Proposed Development – 2 to 6 Conway Avenue, 15 & 15A Fernleigh Avenue, & 38 to 40 Carlisle Street, Rose Bay

Preliminary Assessment of Potential Geotechnical Impacts on Neighbouring Properties

Our ref: JM/C17267_Rev1

Plate 4-2: Graphical Representation of the Depth of Expected Groundwater Drawdown at Distances Extending From the Excavation Boundary (not based on numerical modelling, as this has not been provided by the proponent)

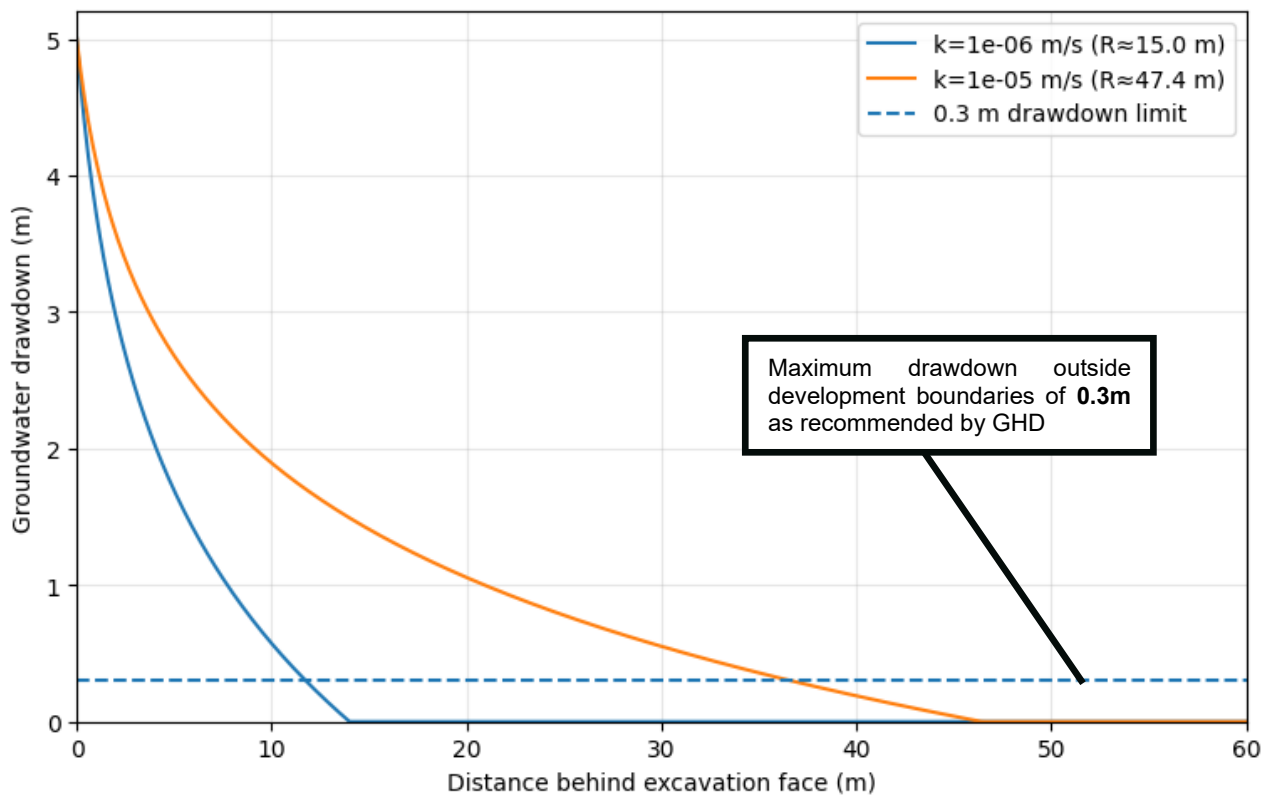
- There are existing structures within 5m to 10m of the proposed excavation, and our estimate is that drawdown of the water table could be greater than 2m depth at this set back distance. The GHD report commissioned by Woollahra Municipal Council states that such drawdown can cause settlement and damage to properties, and therefore recommended that **a limit of 0.3m of groundwater drawdown outside the development boundary** be permissible. Given that we estimate that groundwater drawdown will be greater than this affecting between 20 and 25 neighbouring properties, it is assessed that the proposed development would not comply with Council advice under these conditions.

- Plate 4-2 below is a graph prepared by us based on our own assessment showing the potential groundwater drawdown at set-back distances behind the excavation shoring wall. It should be noted that this is our preliminary estimate, as no numerical modelling has been provided by the proponent.

Plate 5-1 – Indicative markup provided by the client showing the development site (yellow), proposed LMR development sites (red), and known properties that have experience structural damage due to adjacent developments.

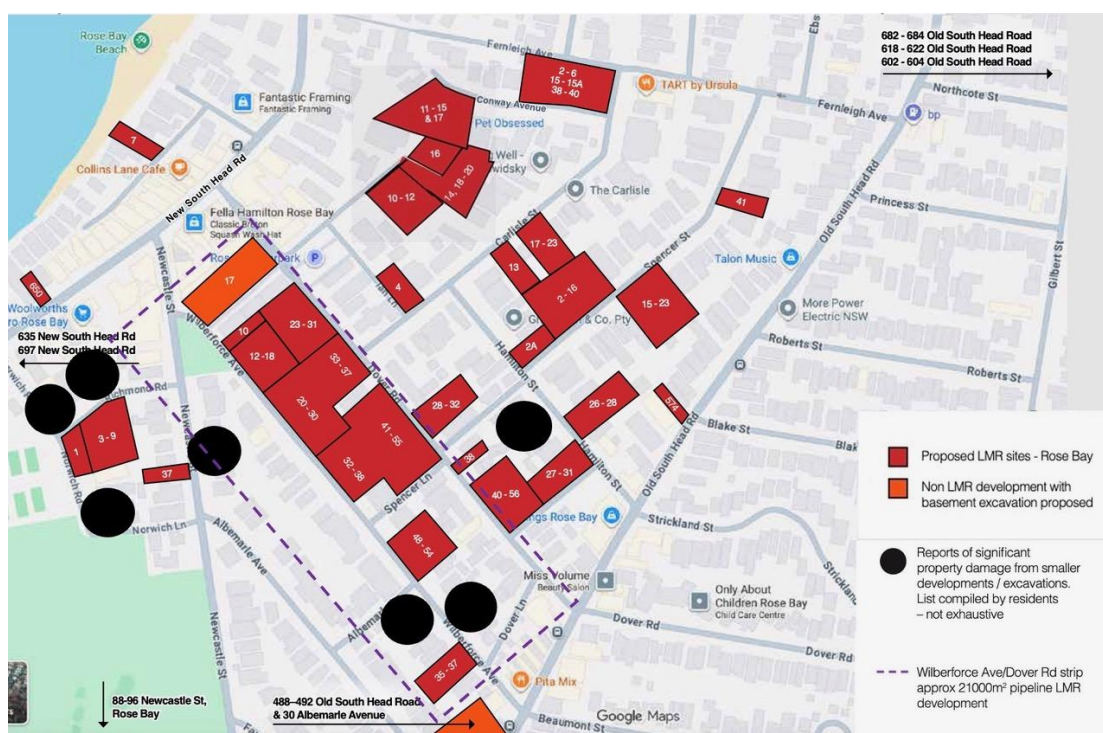
- Numerous instances in Double Bay and Rose Bay of structural cracking and damage to existing houses and apartments which are located near or adjacent to building sites where deep excavations with dewatering are being undertaken. Specific instances where structural damage to neighbouring properties that have been attributed to shoring installation (both from vibrations due to installation of sheet piling and over-flighting for bored piles), excavation and dewatering works in Rose Bay are shown in Plate 5-1 and include:

- o Norwich Lane – back wall came away from the neighbouring house
 - o Richmond Avenue – structural cracks appeared in block of neighbouring units (stop work issued).

- o Wilberforce Avenue – neighbouring house collapsed. The house was deemed unsafe for occupancy and it was subsequently sold and demolished.
 - o Wilberforce Avenue – the same above development caused flooding into the basement of a neighbouring house.

- o O'Sullivan Road – sink holes appeared in the road
